FILE P. I. No. 0008712, Gwinnett County
CSMSL-0008-00(712)
Horizon Parkway Park and Ride Lot

SUBJECT APPROVED PROJECT CONCEPT REPORT

Horizon Parkway Park and Ride Lot Improvements
Gwinnett County

Project Number: CSMSL-0008-00(712)
PI No. 0008712

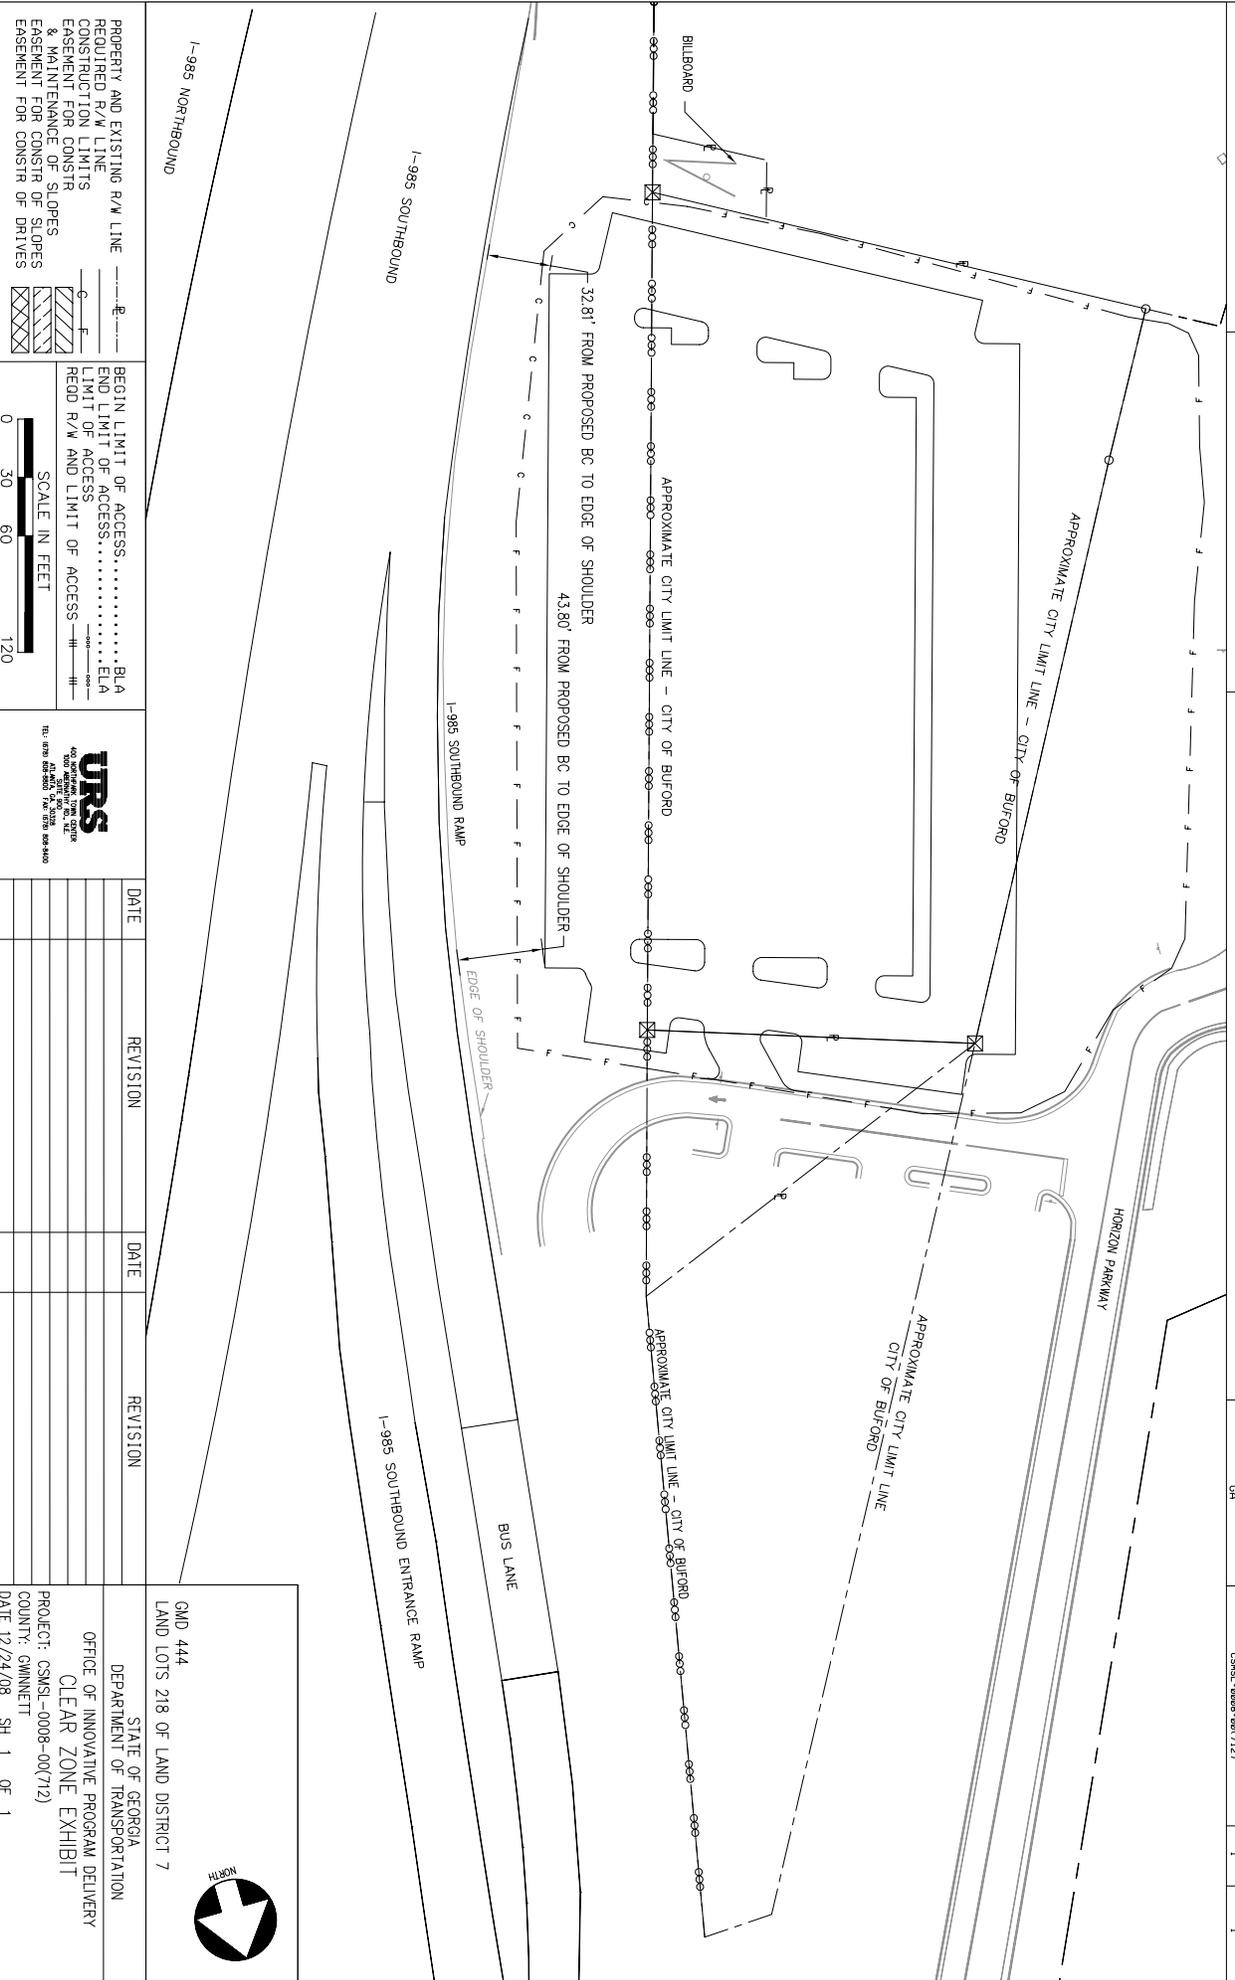
1. Todd: Do we have a BOA with Gwinnett County that we can reference for FHWA purposes? With GDOT and Gwinnett?
2. Pat: Please provide the minimum clear zone dimension based on the current design. Also, let's get dimensions for the northeast and northwest corners, which LaToya mentioned specifically. Not being a freeway designer, I'm not sure of what standards GDOT has for clear zone, or if AASHTO Roadside Design Guide is consulted in each situation. (John-Can you provide some clarification here?)
